Groundwater Transfer Review Summary Form

Transfer/PA # T- 13542 RE-REVIEW

Application: T-13542

Applicant Name: MF Beef Bend, LLC

Modeled Interference: Proposed Well 2 (Original Location) to WASH 50813

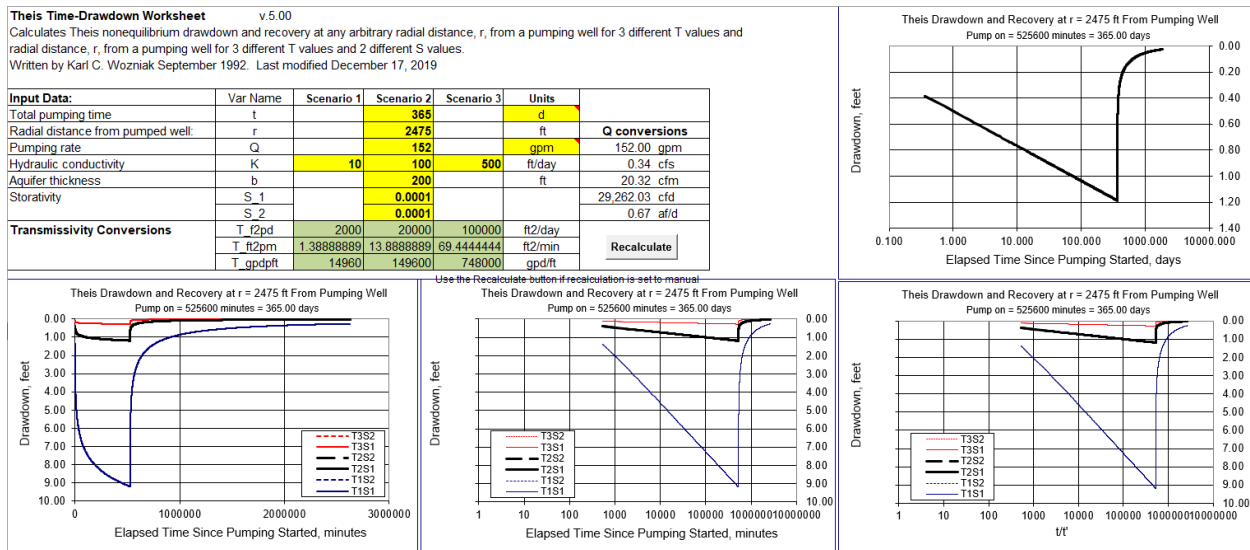
- b) If yes, would this proposed change, at its maximum allowed rate of use, likely result in another groundwater right not receiving the water to which it is legally entitled?
 Yes No Comments: To evaluate potential interference with WASH 50813 (nearest similarly constructed known well location) caused by pumping of APOA Well 2 (WASH 81878), drawdown was estimated using the Theis (1935) analytical solution for a confined aquifer. Hydraulic parameters used for the analysis were derived from nearby pumping test results and from regional data and studies (Conlon and others, 2005), and are within a typical range of values for a comparable hydrogeologic regime (Freeze and Cherry, 1979).
The potential interference between proposed APOA Well 2 (WASH 81878) and WASH 50813 was evaluated with the maximum authorized rate of 0.34 cfs (152 gpm). The results are shown on the attached figures.
Results of the analyses indicate that interference with WASH 50813 due to the proposed change might result in about 9 feet of additional drawdown after continuously pumping for 365 days at the maximum assumed rate for an individual well (0.34 cfs, ~152 gpm). WASH 50813 is 300 feet deep with a reported static water level of 118 ft bls and thus has approximately 180 feet of available drawdown. Consequently, it is unlikely that an additional nine feet of drawdown at WASH 50813 caused by pumping of APOA Well 2 (WASH 81878) (derived using conservative operational and hydrogeologic parameters) will result in WASH 50813 (and other similarly located and completed wells) from receiving the water to which it is legally entitled.

Modeled Interference: Proposed Well 2 (Revised Location) to WASH 50813

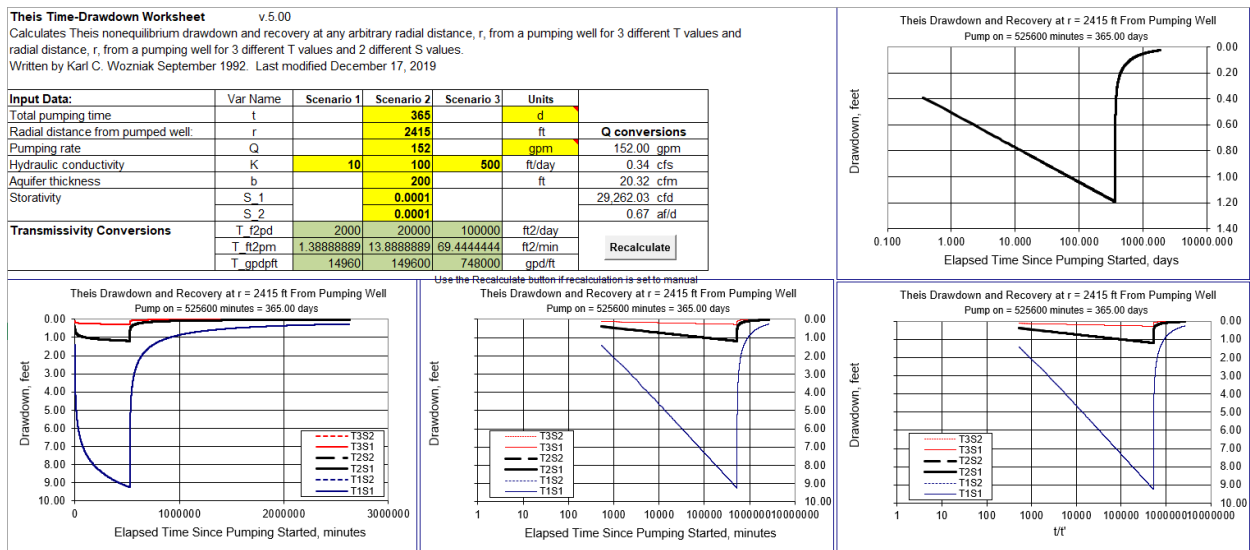
4. a) Will this proposed change, at its maximum allowed rate of use, likely result in an increase in interference with **another ground water right**?
 Yes No Comments: WASH 50813 was identified as the nearest well producing from CRBG and with a similar depth to the proposed APOA.
The proposed location of the APOA could result in an increase in interference.

Well Location Map

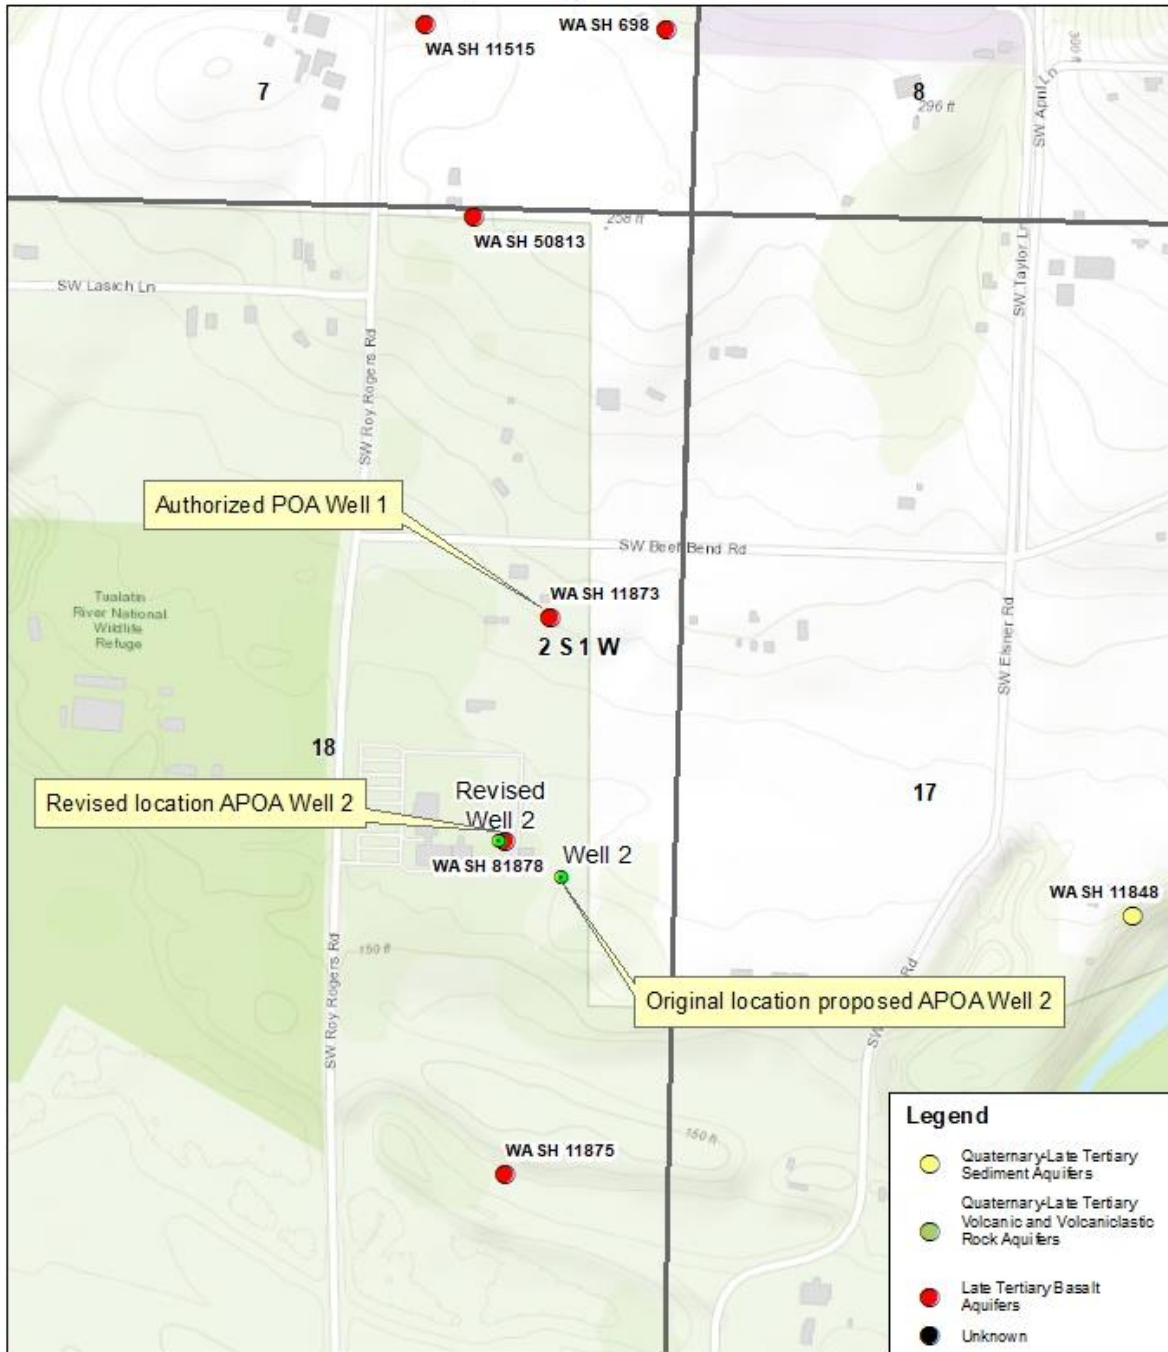
The revised application was submitted on February 6, 2024, at which time Well 2 was proposed and not yet drilled; proposed APOA Well 2 was completed on May 3, 2024 and is identified as WASH 81878. The revised application modifies the **actual final location of proposed APOA Well 2**, which is approximately 275 feet northwest of the originally proposed location. **This re-review is focused on evaluating the actual final location of Well 2 (WASH 81878).**
